STATE OF NEVADA

DIVISION OF ENVIRONMENTAL PROTECTION

Re: **Tronox LLC (TRX)**
NDEP Facility ID #H-000539

Nevada Division of Environmental Protection (NDEP) Response to:
*Revised Excavation Plan for Phase B Soil Remediation of RZ-C, Addendum to the
Removal Action Work Plan, Tronox LLC, Henderson, Nevada*

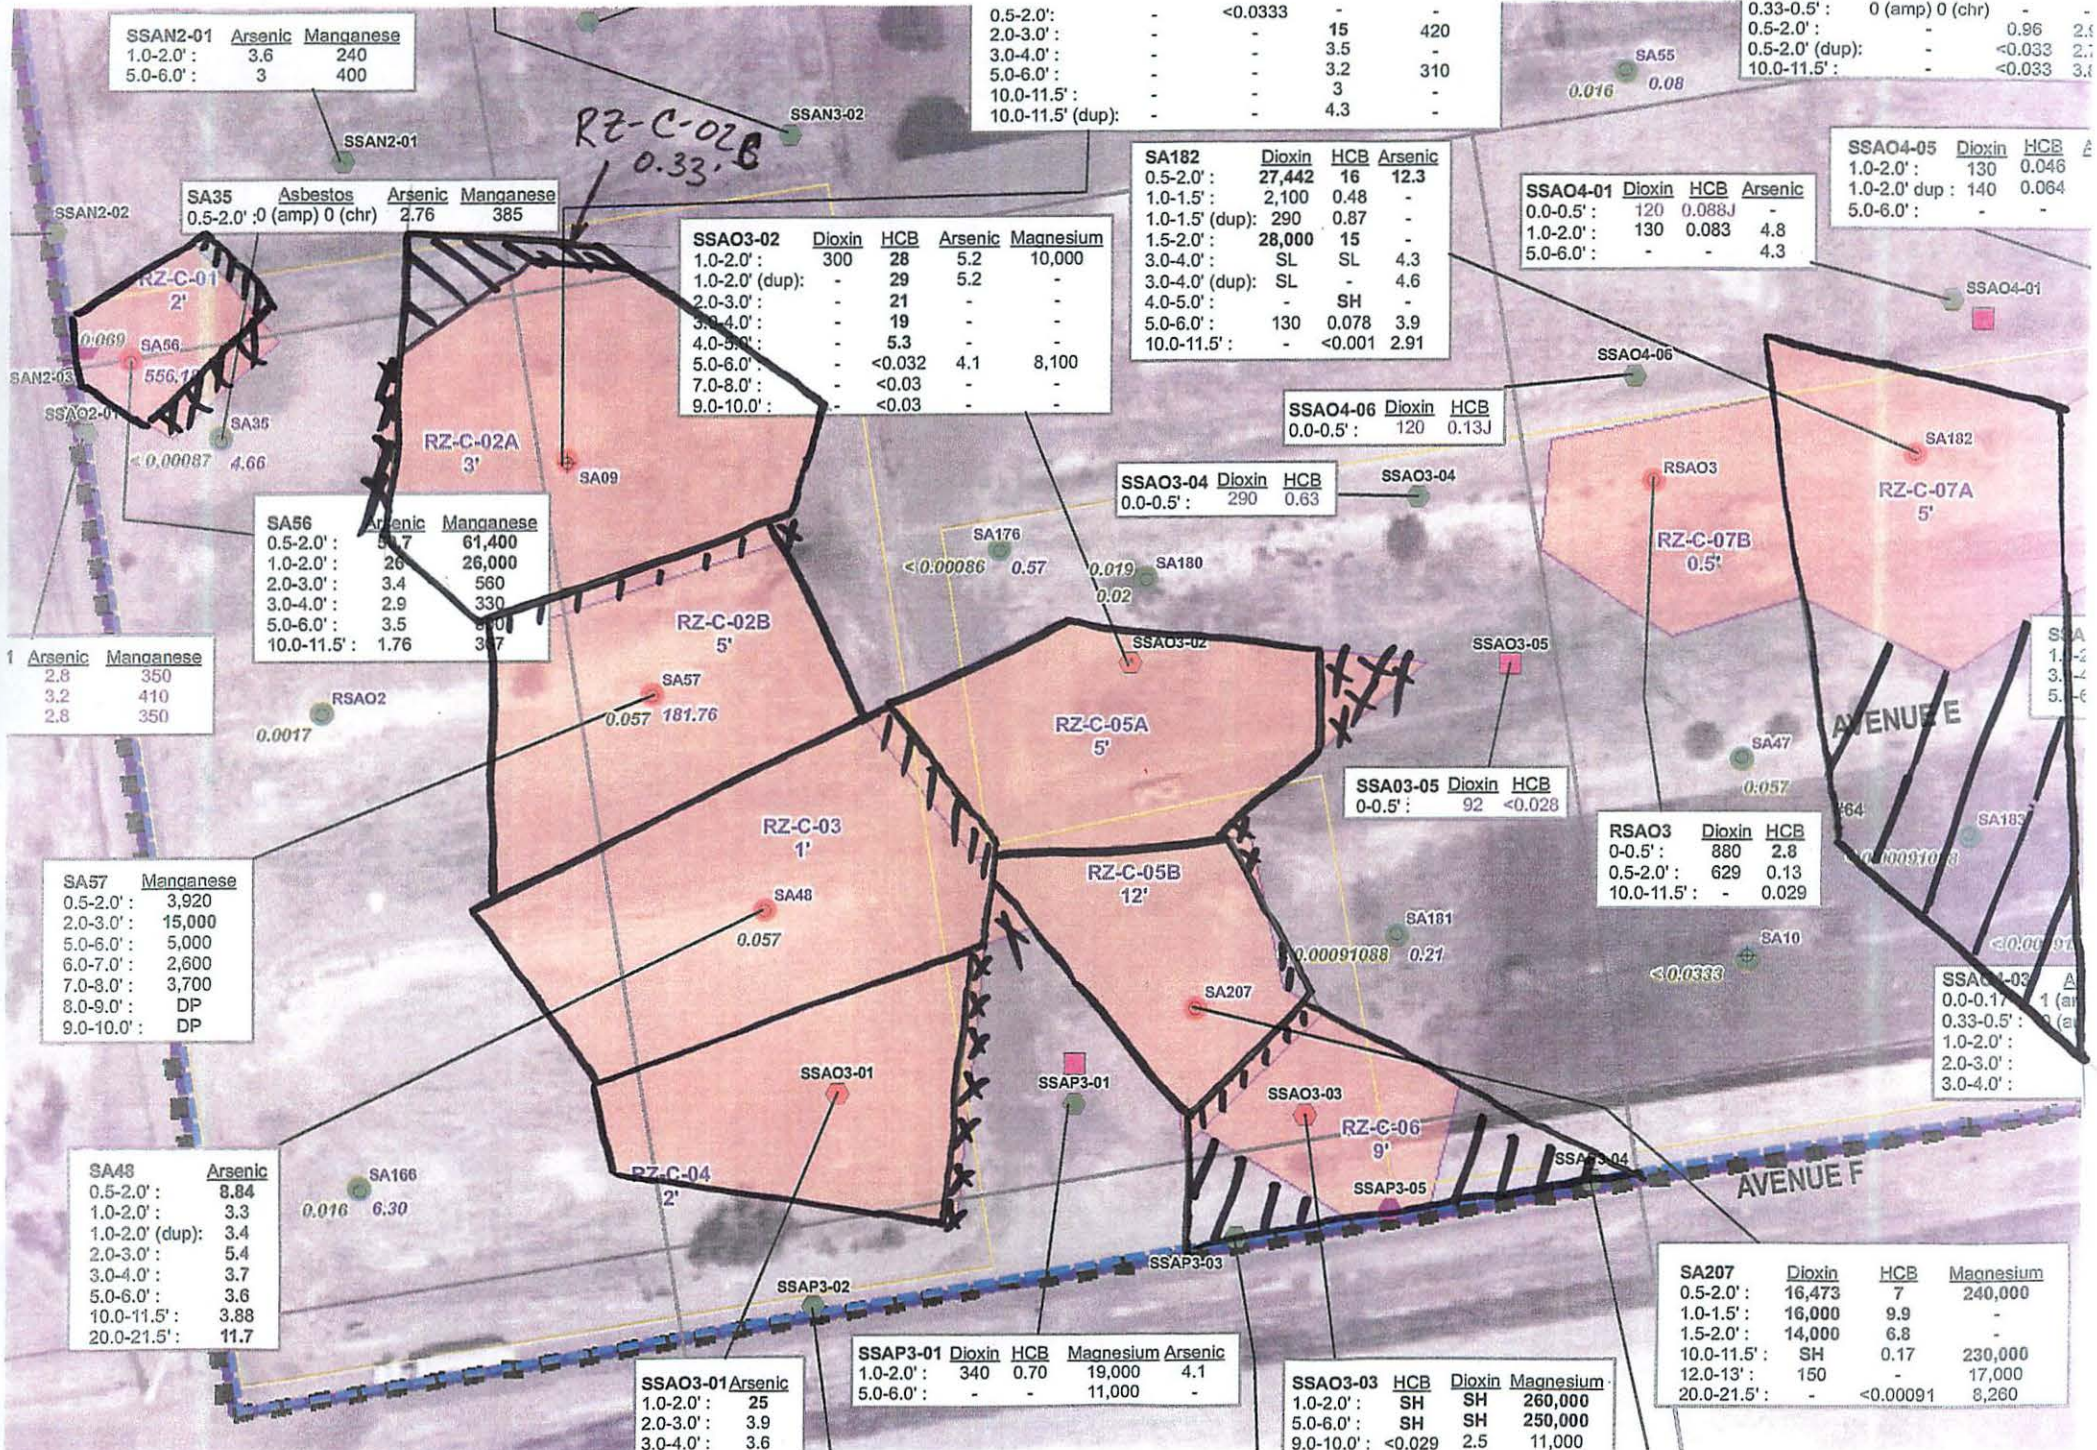
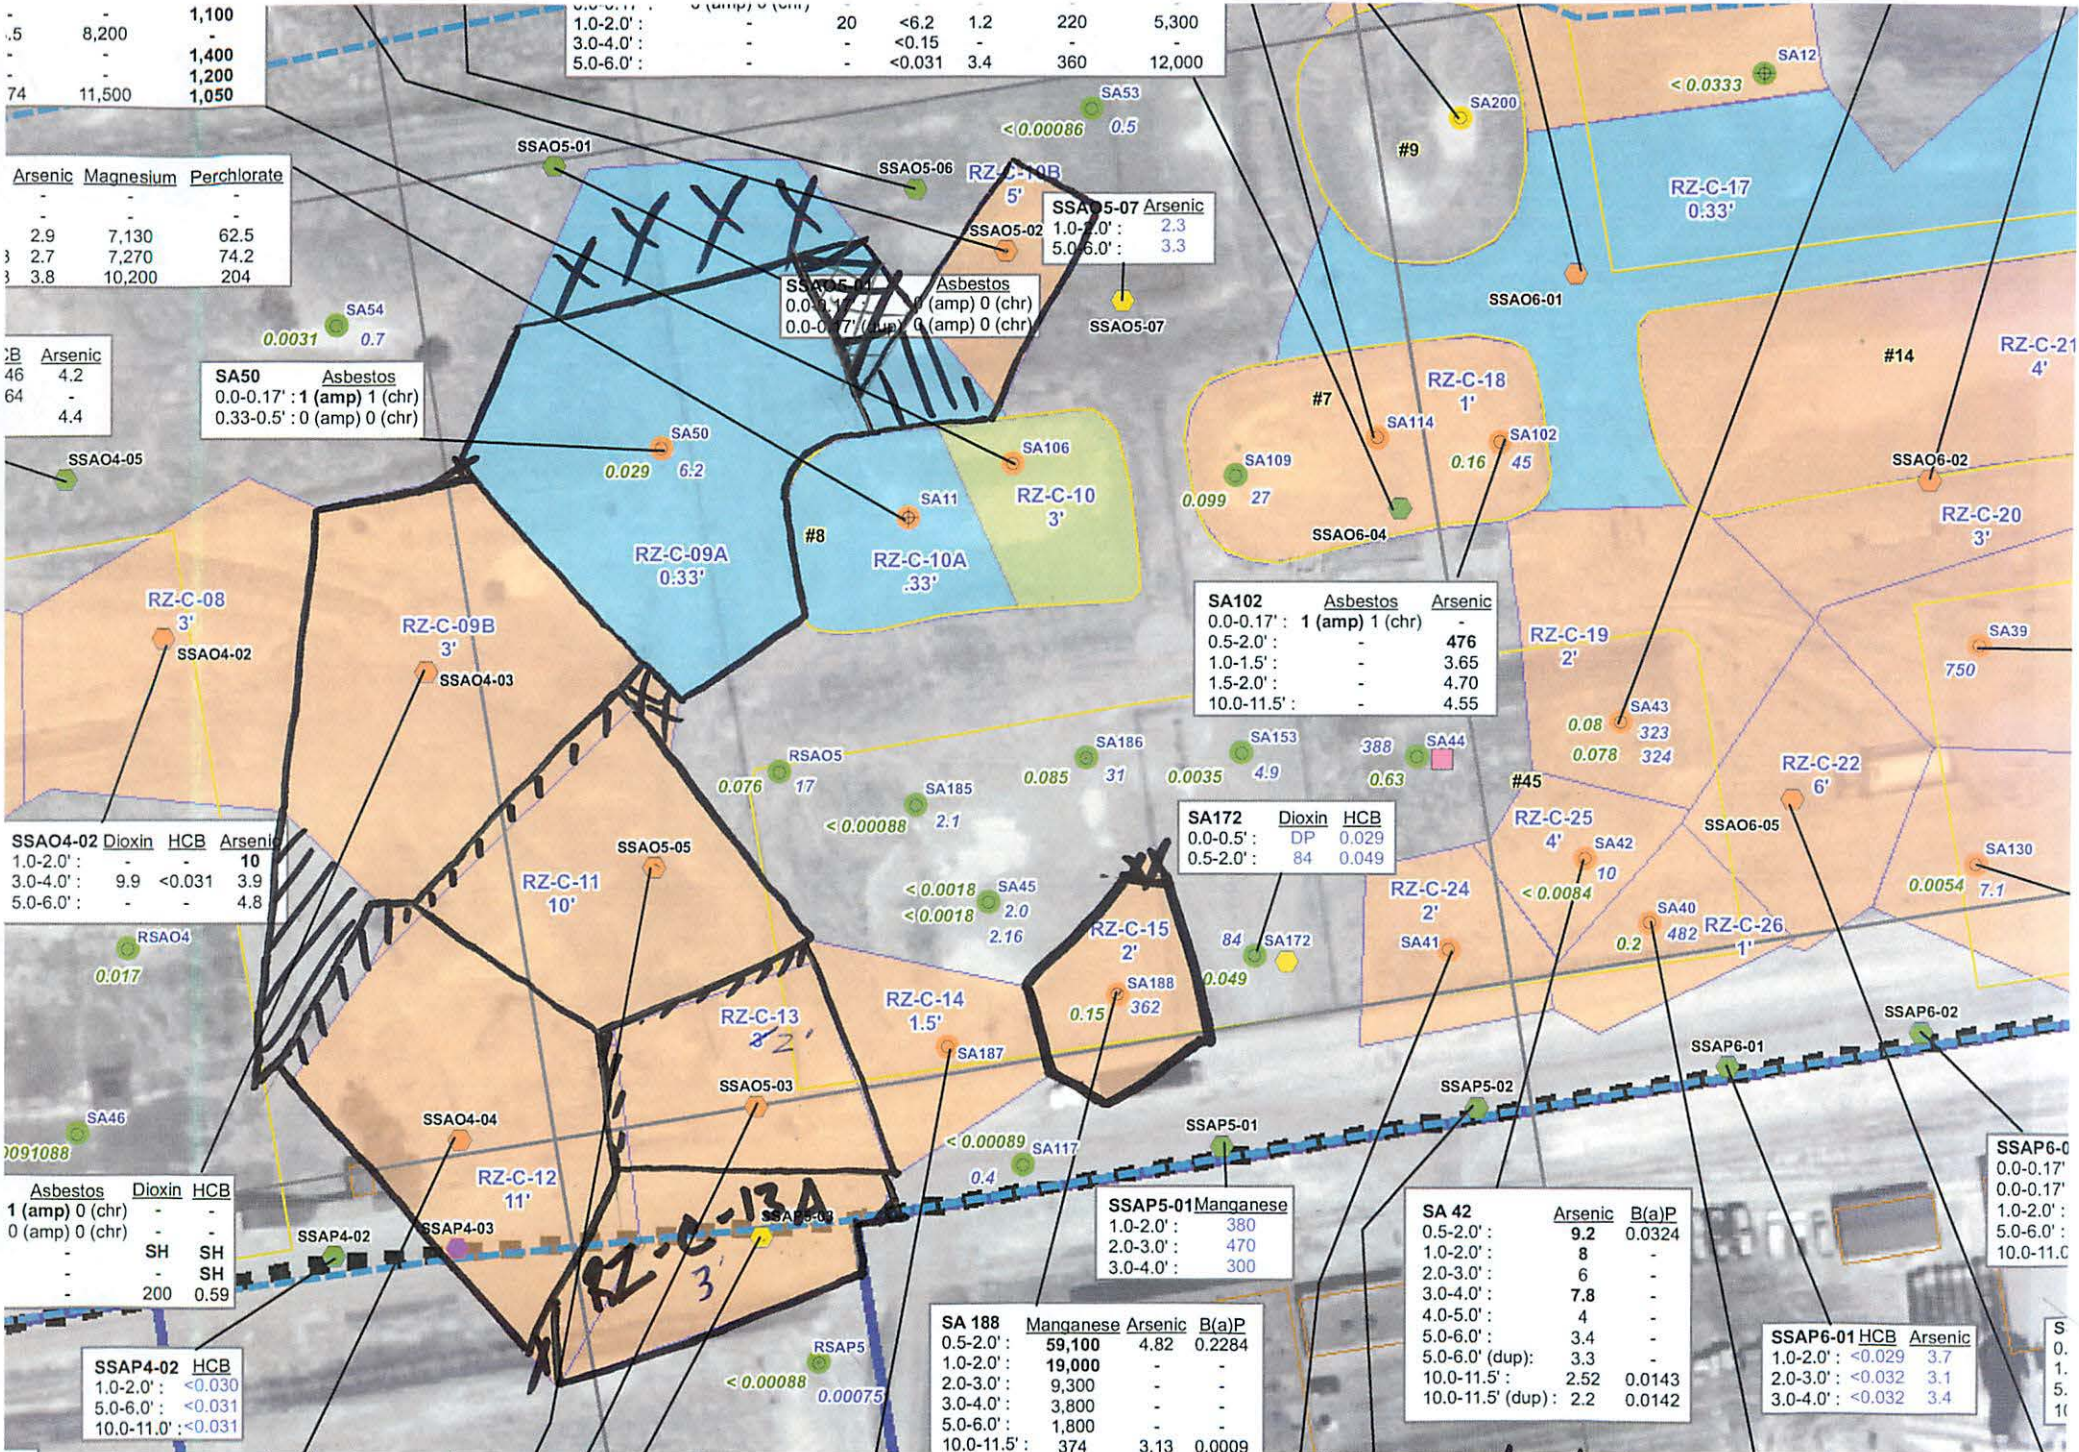
The following Figures are excerpts from Figure 1: RZ-C Excavation Areas and Nature and Extent of Contamination (dated October 12, 2010). NDEP has provided approximate revisions to excavation limits to illustrate the comments made in the Attachment B Table as well as based on comment 2 of Attachment A.

C-8

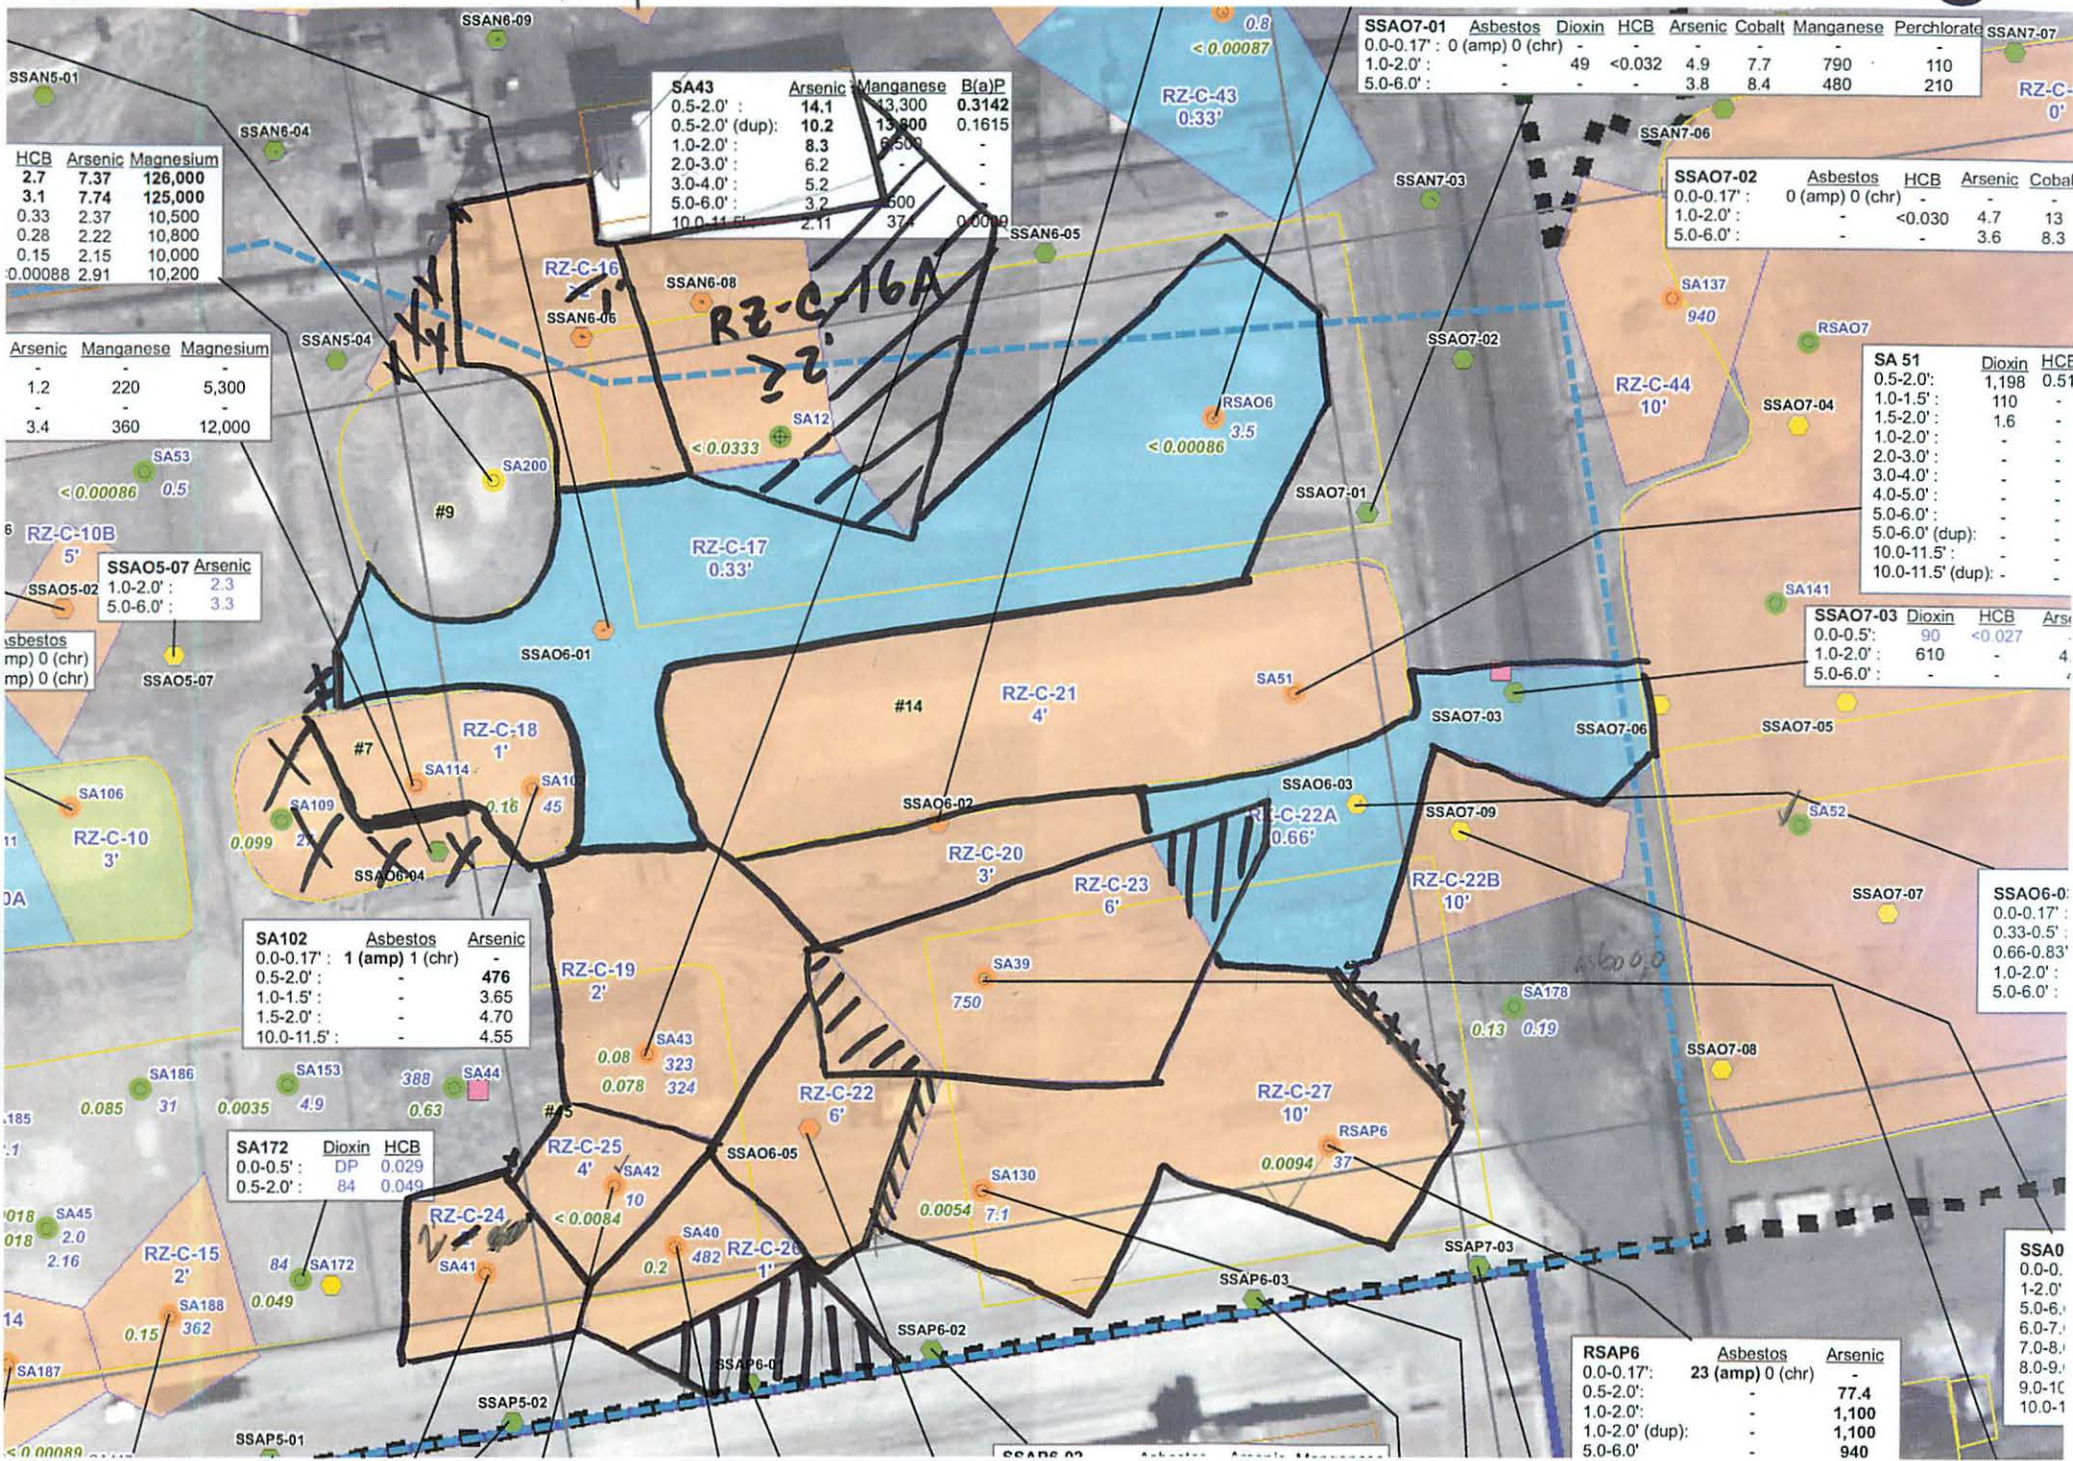
Please note that Figures C-7 and C-8 are included for the revisions that will be necessary once the asbestos results are received for SA113. Figure C-7 is for the scenario where the asbestos results are less than the comparison levels resulting in the reduction of RZ-C-39A. Figure C-8 are for the scenario where the asbestos results are greater than or equal to the comparison levels resulting in the increase of RZ-C-39A.

* if asbestos results for SA113 are \geq comparison levels
 - only RZ-C-28C, RZ-C-39, & RZ-C-39A revised limits shown
